RECOMMENDED SERVICE BULLETIN NO. RSB 40NG-079 REV. 0

Installation of a stiffener on the alternator cable.

WORK INSTRUCTION WI-RSB 40NG-079 REV. 0

Installation of a stiffener on the alternator cable.

Figure 1. Ring terminal

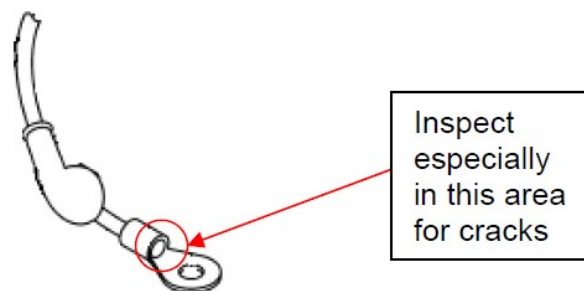
1. Disconnect the airplane main battery. Refer to AMM Section 24-31.
2. Remove the top and bottom cowlings. Refer to AMM Section 71-10.
3. Disconnect the alternator cable 24007A4 from the alternator.
4. Move the insulating boot from the alternator cable back and inspect the ring terminal for cracks. Refer to Figure 1.
 - If cracks are found, replace the existing alternator cable with a new alternator cable (item 4) and proceed to step 6. Refer to AMM Section 24-30.
 - If there is no crack, proceed to step 5 to install the stiffener (item 1).

Figure 4

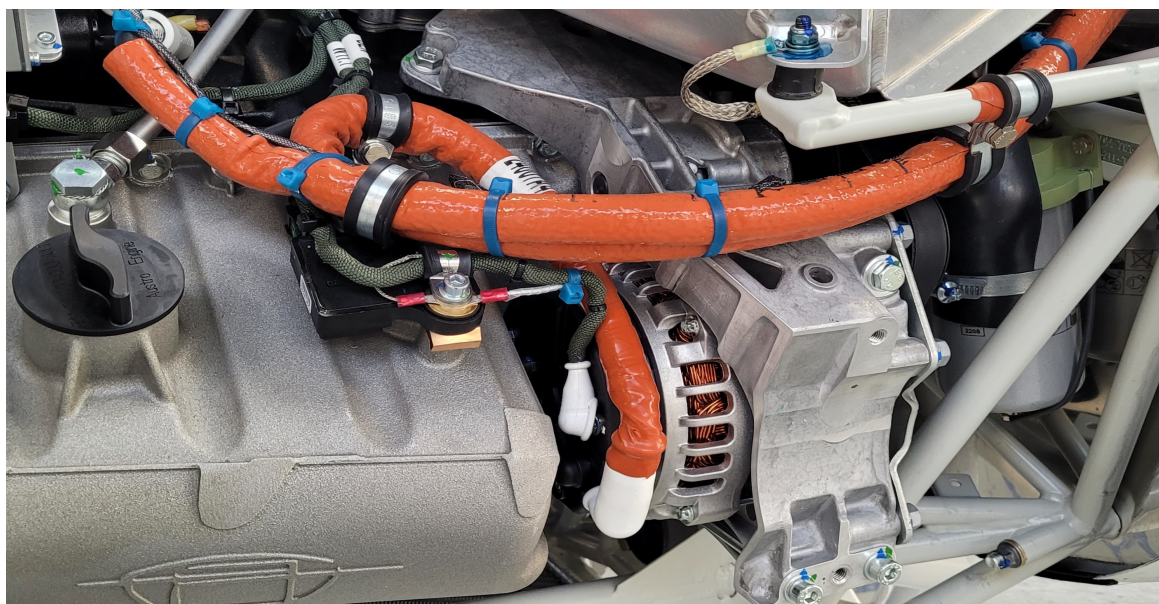
6. Connect the alternator cable to the alternator and install the insulating boot. Make sure that the alternator cable routing and the cable tie positioning are carried out as shown in Figure 4.

NOTE: Make sure that there is no tension on the alternator cable and enough flexibility for the relative movement of the engine.

CAUTION: When installing the alternator cable to the alternator it is not allowed to bend the ring terminal of the alternator cable. Bending the ring terminal may lead to its breakage during operation.
